## **ADDENDUM**

**PROJECT:** Forestside Estates  
Attmar & Palleschi Drive  
Brampton, Ontario

**PROJECT NO.:** 18-017

**ADDENDUM NO.** E-3

| TITLE | ROOF PLAN<br>ELECTRICAL |

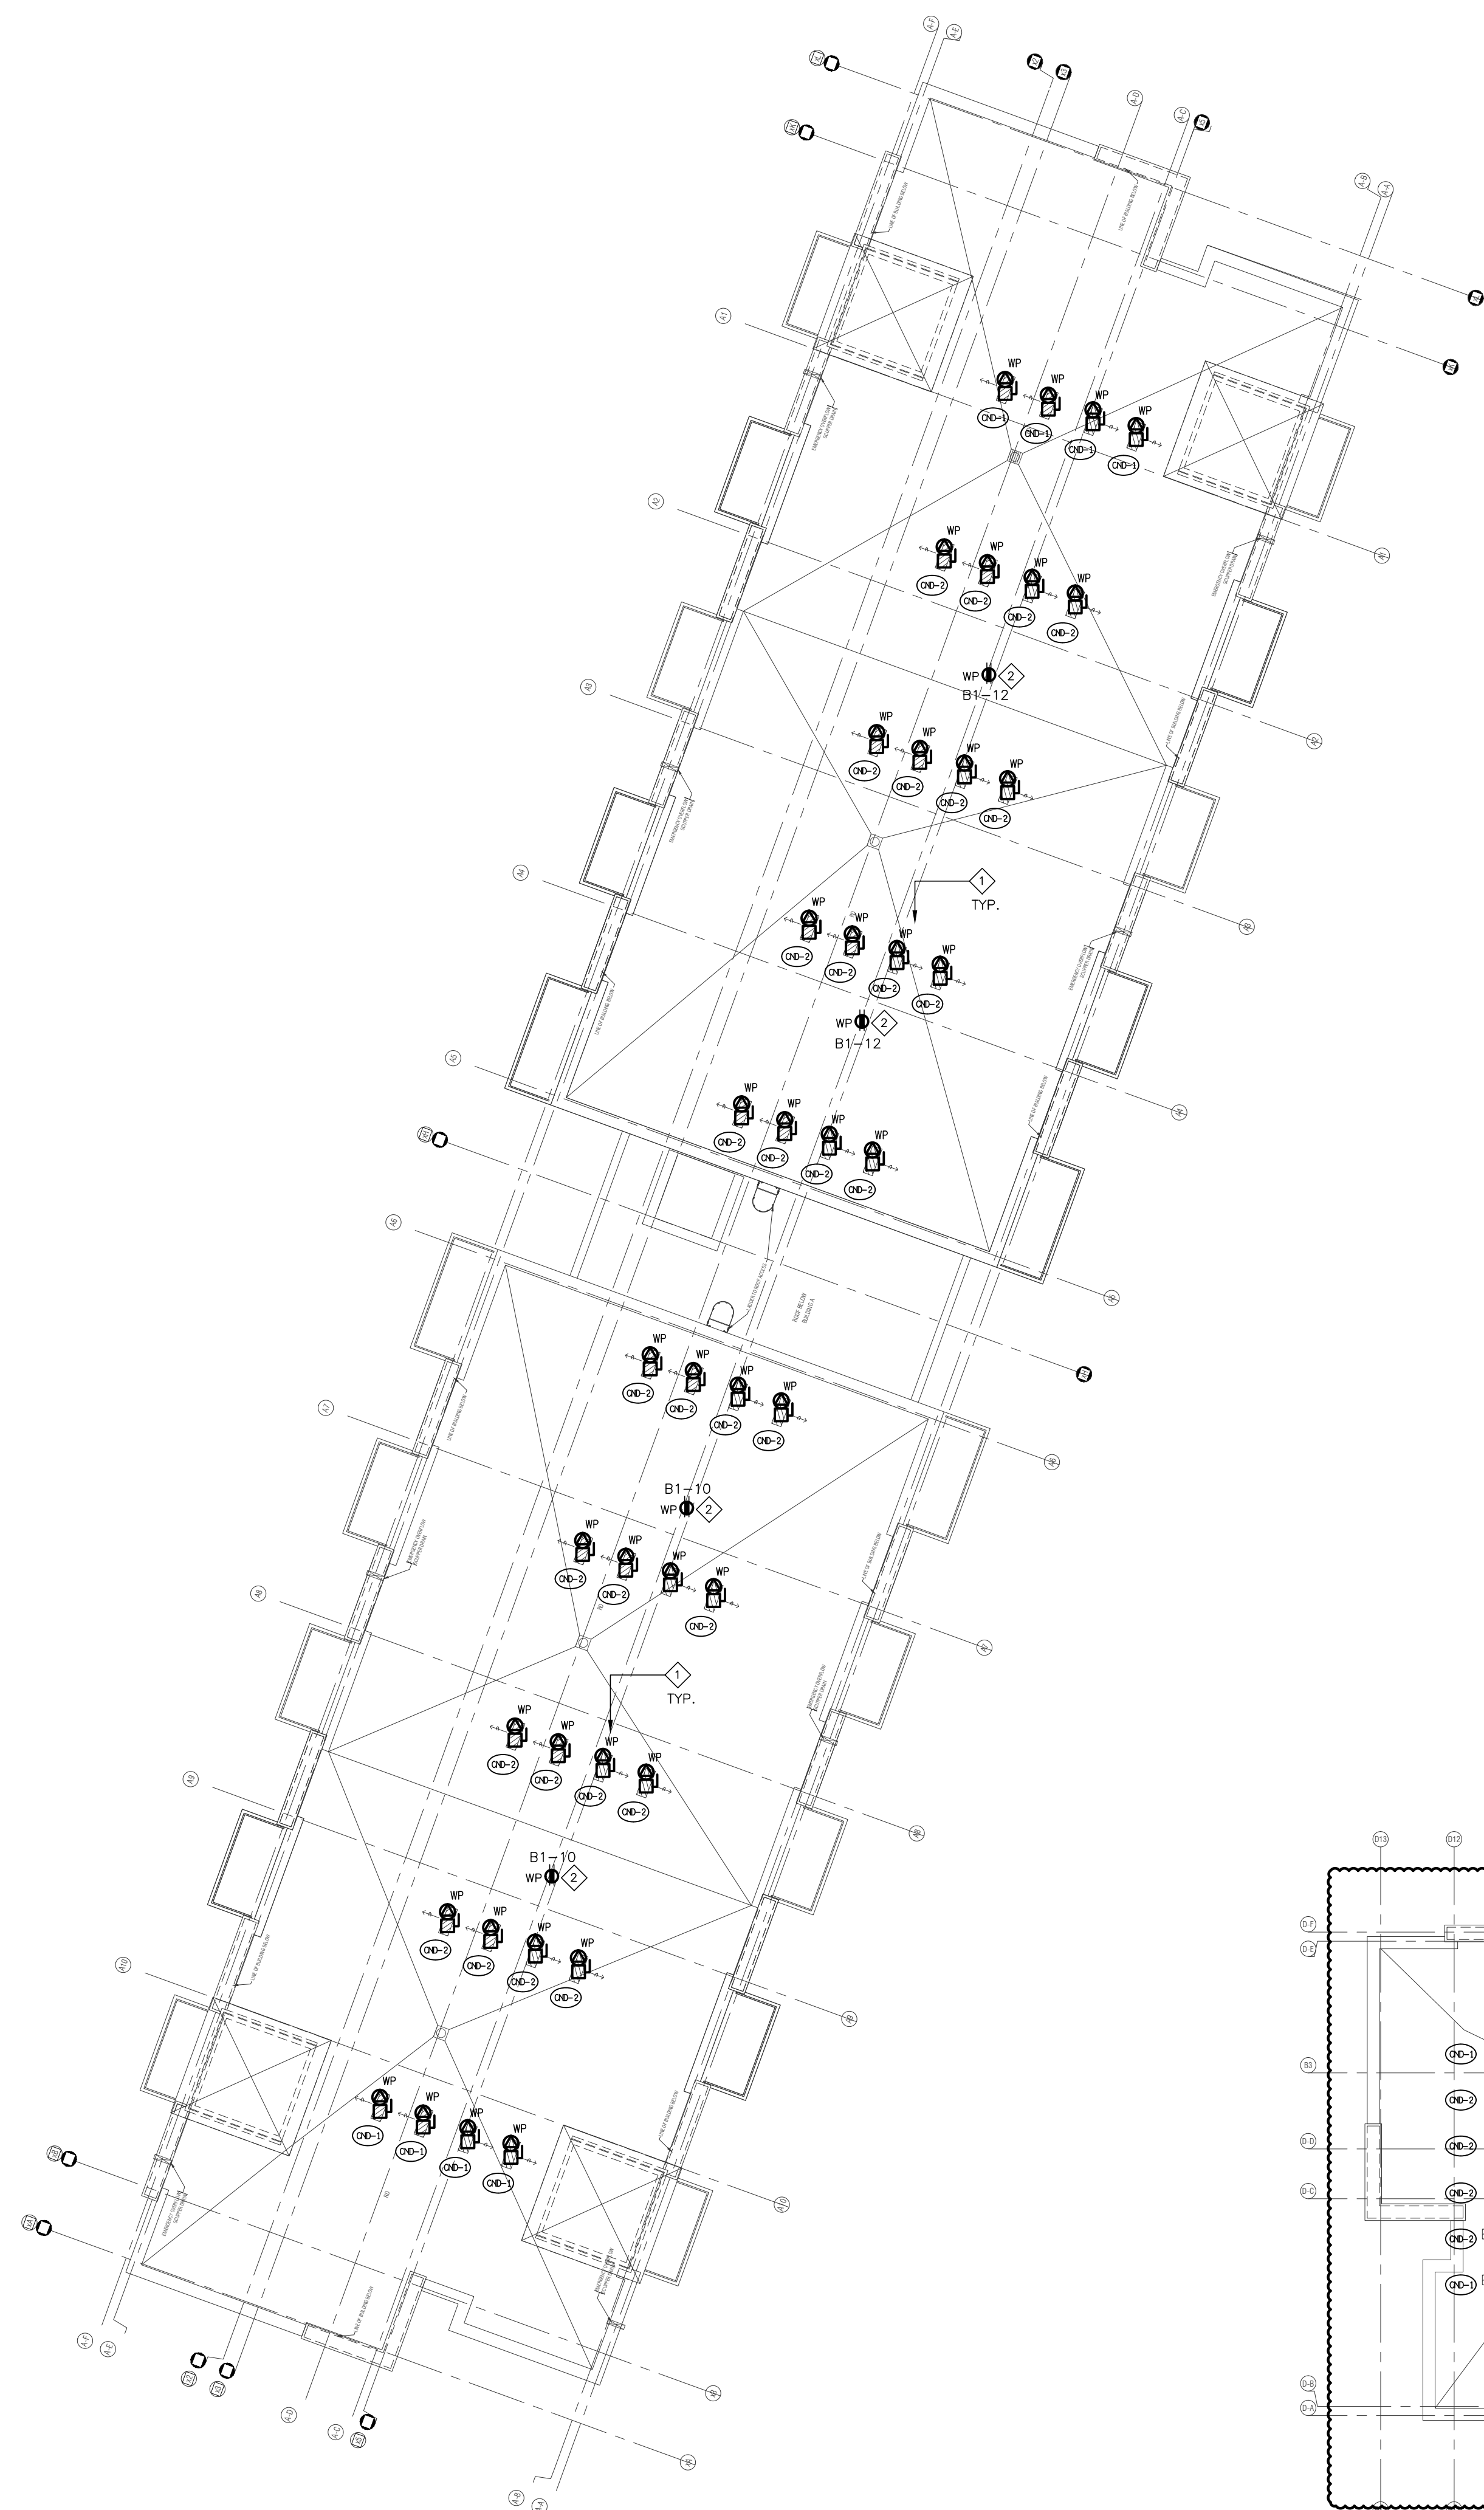
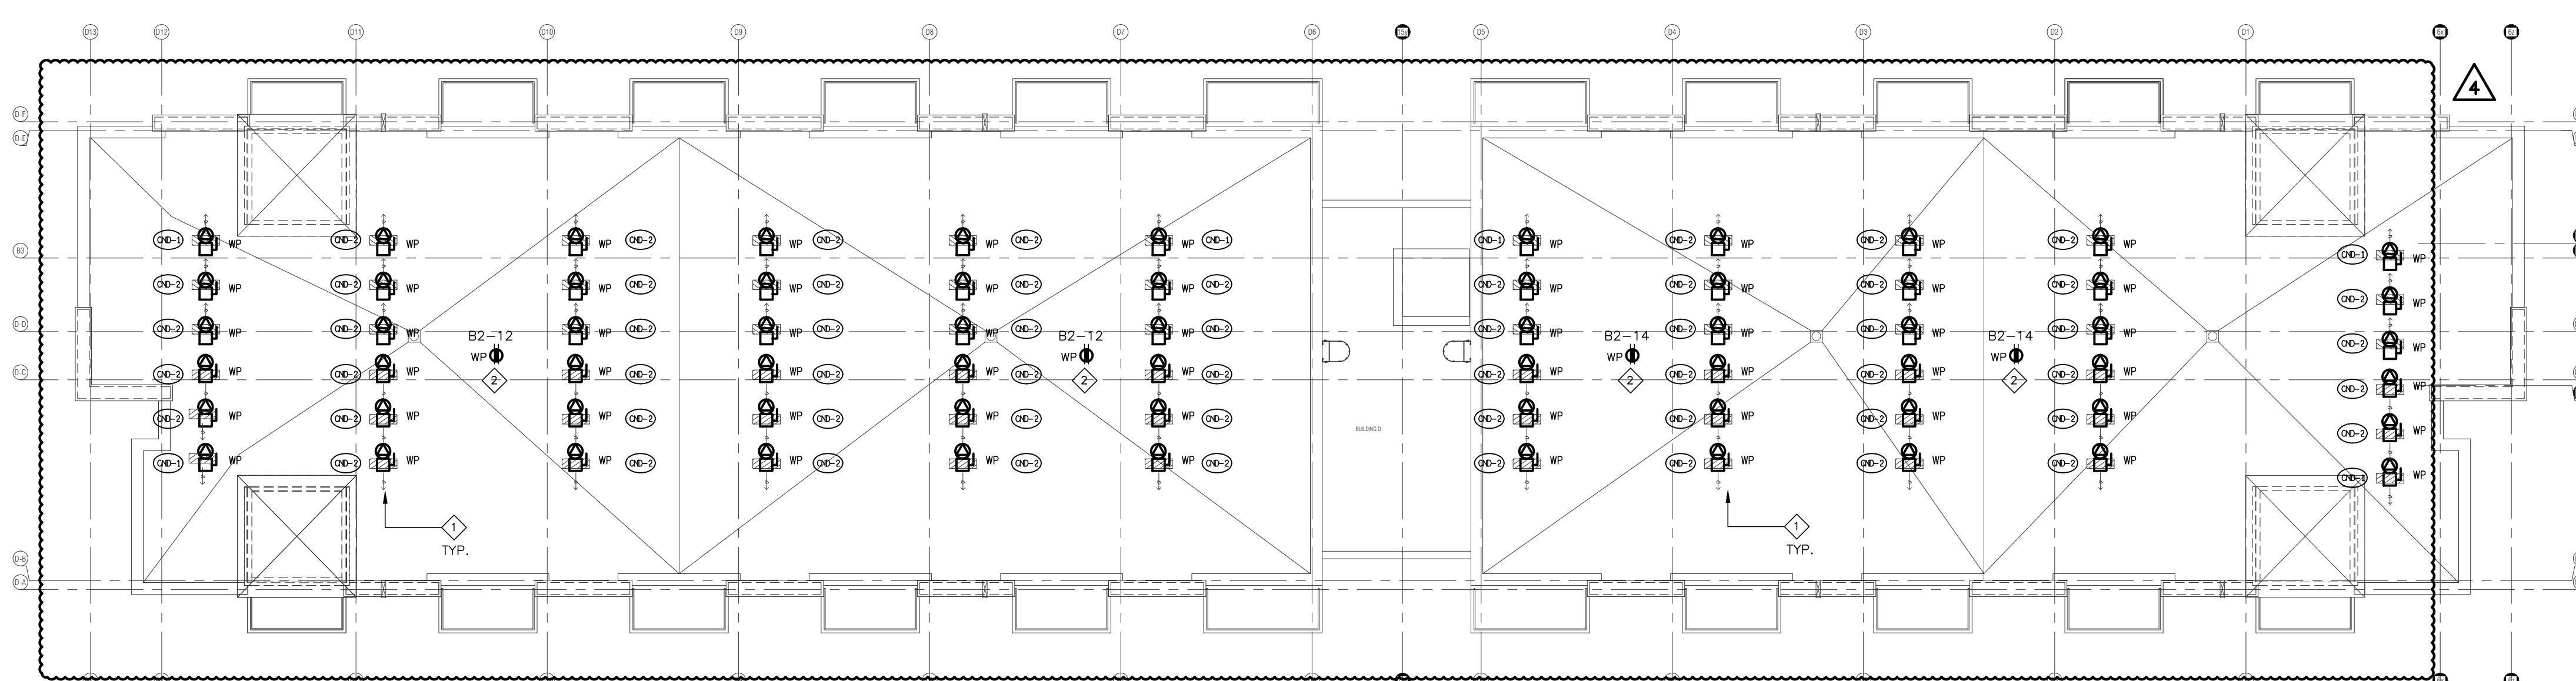
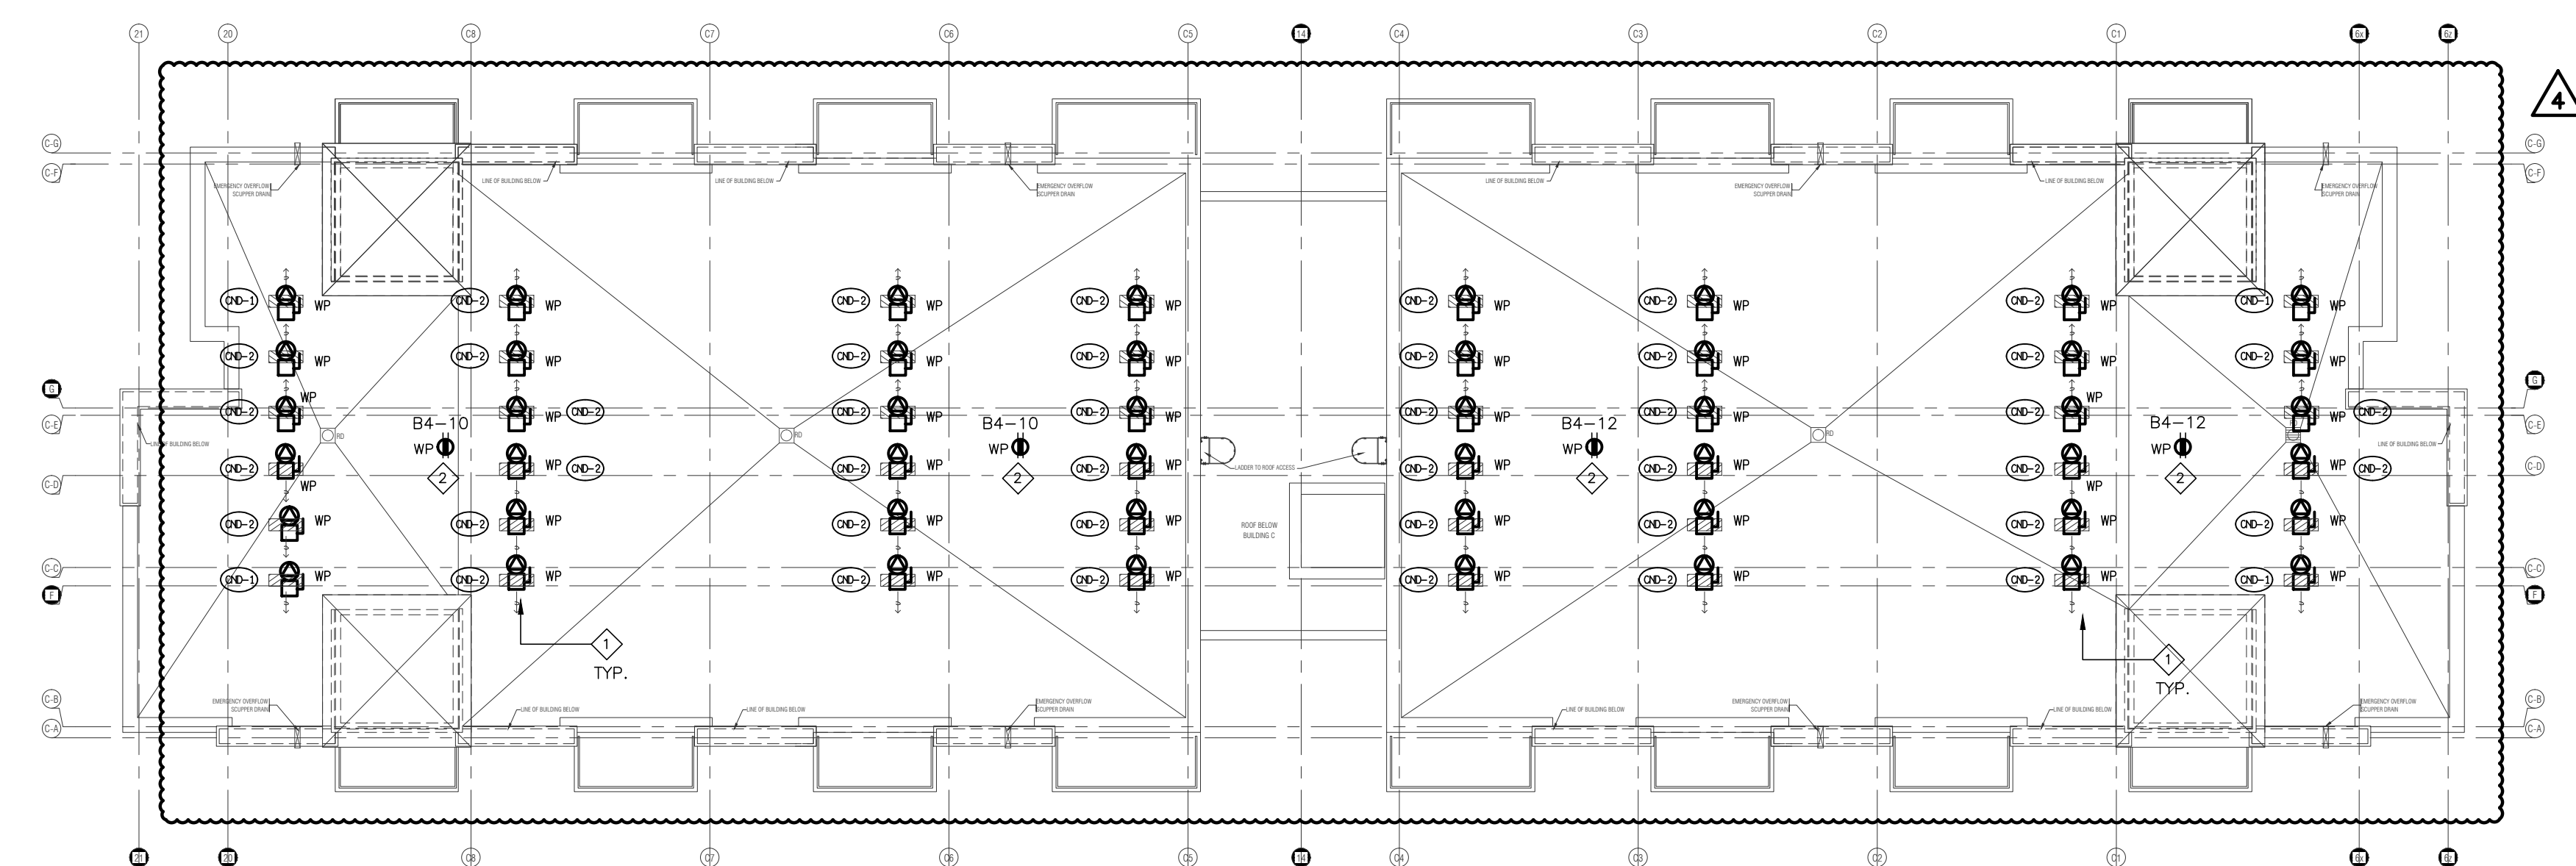
**2.0 Reference Drawings E-3 (Ground Floor - Electrical) Issued**  
**E-4 (2<sup>nd</sup> Floor- Electrical)**  
**E-5 (3<sup>rd</sup> Floor- Electrical)**  
**E-6 (4<sup>th</sup> Floor- Electrical)**  
**E-7 (Roof- Electrical)**

2.3 Relocate: Condensing units on the roof to suit mechanical drawings
